Access Compliance Report Public Rights-of-Way (Pedestrian Signals)

Main Street: GILBERT_ST Cross Street: GUINIDA_LN Location: NE

ADA ID: SGRK210924121827 Signal Type: One Push Button-APS Overall Compliance: No Severity Scores: BTN 1: 35 BTN 2: N/A No BTN: N/A

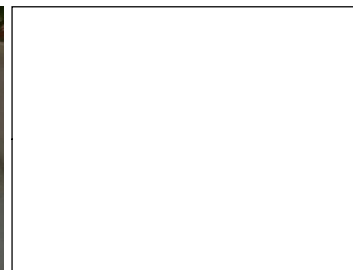
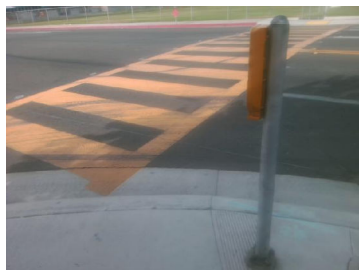
OC Std/PROW: R404.2, MUTCD 4e.08

Possible Solutions: Replace Signal Push Button With APS Button. Remove and Replace Clear Space.
